UNITED STATES PATENT AND TRADEMARK OFFICE

APPLICATION NO.	FILING DATE	FIRST NAMED INVENTOR	ATTORNEY DOCKET NO.	CONFIRMATION NO.
10/676,356	10/01/2003	Roger D. Buck	WK/2003-06/US	7148

Office Action Summary

DETAILED ACTION

FIG. 1A.

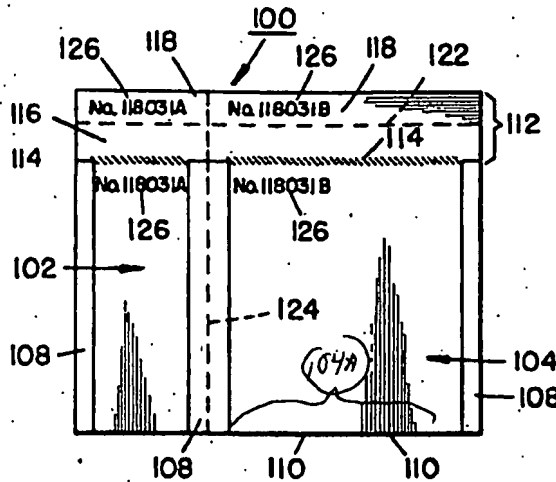
8. Claims 1,3,7-9,11,12,16,19,20,24 and 25 are rejected under 35 U.S.C. 103(a) as being unpatentable over Makowka (4,733,817) in view of Kraft et al. (5,393,264). Makowka discloses in Fig. 1A-4 and in Attachment I, a business form assembly, a business form intermediate, and sample collection assembly comprising a first carrier layer (104) of a first dimension having a first ply (106A) and a second ply (110A); wherein the plies have a first and second longitudinally extending side edges (104A and 104B, as seen in Fig. 1C of Attachment I) and first and second transversely extending edges (104C and 104D, as seen in Fig. 1C of Attachment I); wherein the plies are secured to one another along the transversely extending end edges (104C and 104D, as seen in Fig. 1C of Attachment I) and secured along one of first and second longitudinally side edge (104A, as seen in Fig. 1C of Attachment I) to create an access opening (111A, as seen in Fig. 1C of Attachment I); wherein each of the first and second plies having a length and a width, wherein the length and width of one ply is longer and wider than the other ply (see Fig. 1B), wherein the ply with the longer width forms a flap (116A) for securing;

a plurality of recordation layers (118 or 218) having first and second transversely extending end edges (118A and 118B) and first and second longitudinally extending side edges (118C and 118D) and having a third dimension distinct from the carrier layer and collection layer (see Fig 1A); wherein each of the carrier layer, collecting layer and recordation layer are connected along the longitudinal extending edges (118A, 104B, 102B); wherein each of the layers have at least one transversely extending edges substantially aligned with one another; wherein the collection layer is suitable for receiving material items; and wherein the collection layer can include an inner envelope (which consist of an additional film layer as stated in col. 3, lines 22-37, and extra films for padding col. 3, lines 38-46).

FIG. 4.

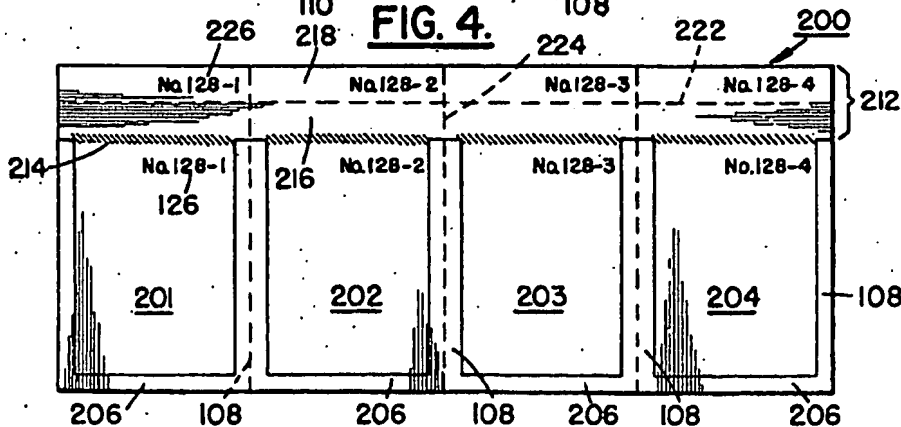
10. Claims 22 and 27 are rejected under 35 U.S.C. 103(a) as being unpatentable over Makowka in view of Kraft et al., further in view of Harmanoglu (6,619,843). Makowka in view of Kraft et al. discloses a business form assembly, business form intermediate, and sample collection assembly comprising all the elements as claimed in claims 19 and 24, and as set forth above. Makowka in view of Kraft et al. further discloses wherein the recordation layer (218) can

be a plurality of layers (see Fig. 4). However, Makowka in view of Kraft et al. does not disclose wherein the intermediate is provided with a plurality of removable labels.

FIG. 1

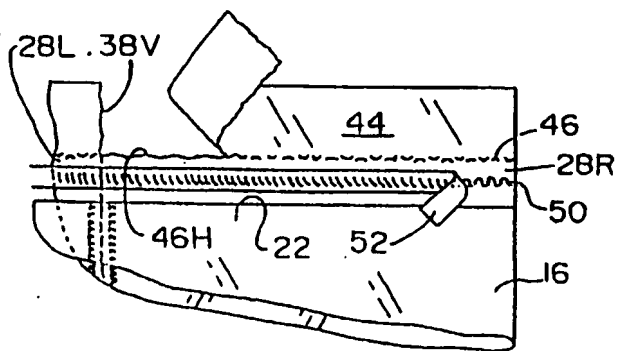
11. Claims 1,3,4,19 and 24 are rejected under 35 U.S.C. 103(a) as being unpatentable over Harmanoglu (6,619,843) in view of Kraft et al. (5,393,264). Harmanoglu discloses in Fig. 1 and in Attachment II, a business form assembly, a business form intermediate, and sample collection assembly comprising a first carrier layer (26) of a first dimension having a first ply (12A) and a second ply (16A); wherein the plies have a first and second longitudinally extending side edges (26A and 26B, as seen in Fig. 1 of Attachment II) and first and second transversely extending edges (26C and 26D, as seen in Fig. 1 of Attachment II); wherein the plies are secured to one another along the transversely extending end edges (26C and 26D, as seen in Fig. 1 of Attachment II) and secured along one of first and second longitudinally side edge (26A, as seen in Fig. 1 of Attachment II) to create an access opening (22); wherein each of the first and second plies having a length and a width, wherein the length and width of one ply is longer and wider than the other ply (see Fig. 1); wherein the ply with the longer width forms a flap (28R) for securing;

a second collection layer (24) comprised of first (12B) and second ply (16B); wherein the plies have a first and second longitudinally extending side edges (24A and 24B, as seen in Fig. 1 of Attachment II) and first and second transversely extending edges (24C and 24D, as seen in Fig. 1 of Attachment II); wherein the plies are secured to one another along the transversely

a recordation layer (28) having first and second transversely extending end edges (28A and 28B) and first and second longitudinally extending side edges (28C and 28D) and having a third dimension distinct from the carrier layer and collection layer (see Fig 1); wherein each of the carrier layer, collecting layer and recordation layer are connected along the longitudinal extending edges (28A, 26B, 24B); wherein each of the layer have at least one transversely extending edges substantially aligned with one another; wherein the collection layer is suitable for receiving material items; removable label having first part (44A) and second part (44B).

FIG. 3

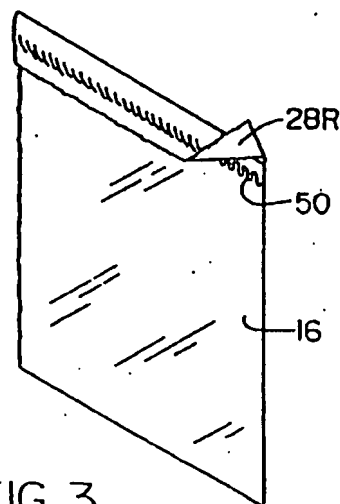
wherein the collection layer having a different and larger dimension from the carrier layer and a recordation layer; wherein the closure flaps for both the carrier and collecting layer having two lines of weakness (fold line to fold flap as seen in Fig. 3), and two sealing closures (50R and 50L);
